P 515050

SEWAGE DISPOSAL SYSTEM

HOWARD COUNTY HEALTH DEPARTMENT

SUBDIVISION Peacefields at Cattail LOT NUMBER 6 ADDRESS 15541 Cattail Oaks

NOT TO SCALE

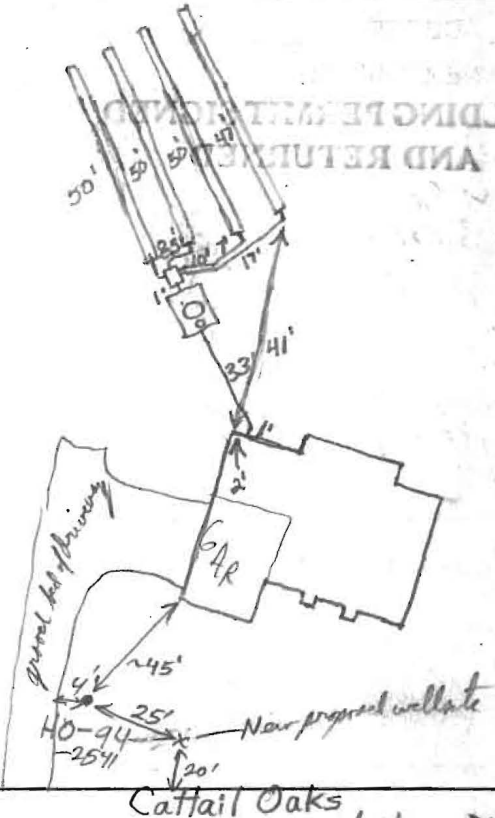
PRE-CONSTRUCTION INSPECTION: 5/11/01 Due to contour problems and loss of area, to install 4-50' trenches, two foot wide, four feet of stone, 7' spacing, to maximize use of area. (BB) 5/21/01 System satisfactory. O.K. to cover. (BB)

Parts of Easement Unusable - See BP Plan
